NRC Pre-Application Meeting MAP Package Amendment Docket No. 9319

December 10, 2024

Drawing Changes

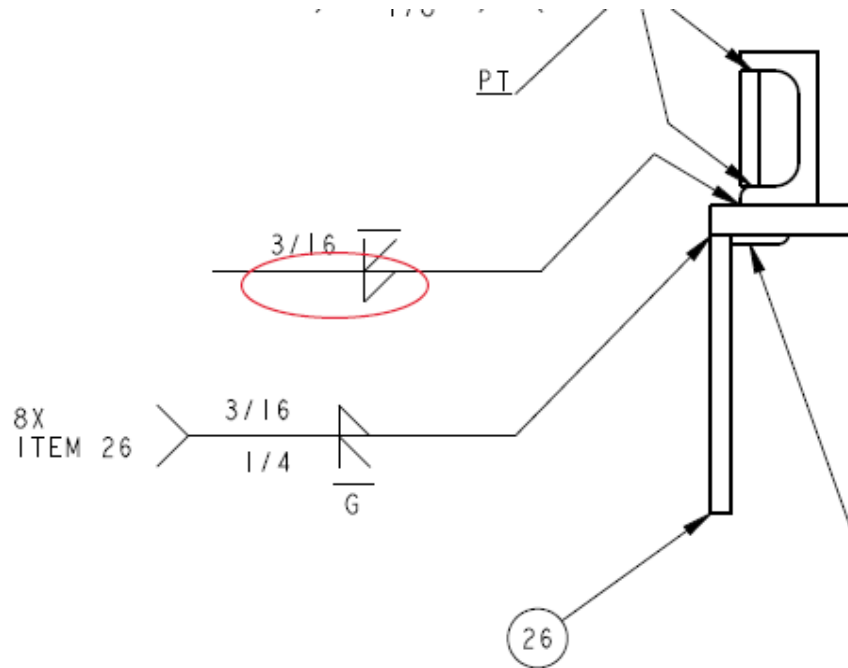
- All changes implemented to facilitate fabrication of new packaging
- Drawing 9045393 - BOM
 - ◆ Revised part number of items 53, 54, and 58 to reflect current Cherry Aerospace rivet nomenclature
 - ◆ Revised items 44, 45, 55, and 68 to include “OR EQUIV” to facilitate procurement of equivalent parts
 - ◆ Revised part number of item 55 to include next size rivet to allow appropriate grip length (with flag note)

■ Drawing 9045403

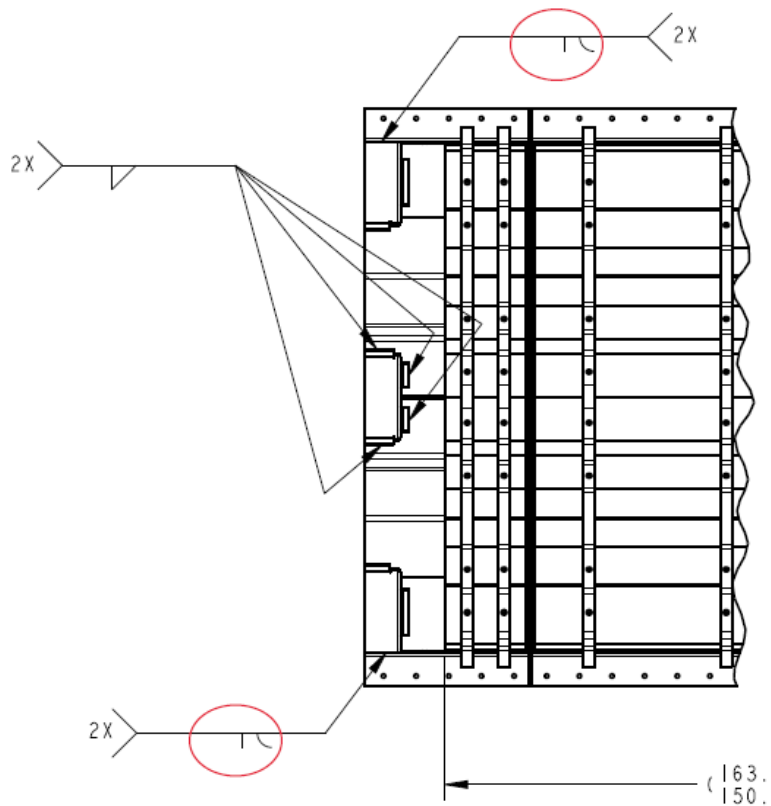
- ◆ Removed 1/8" weld size callout on flare bevel weld due to thickness of base material of 0.09"
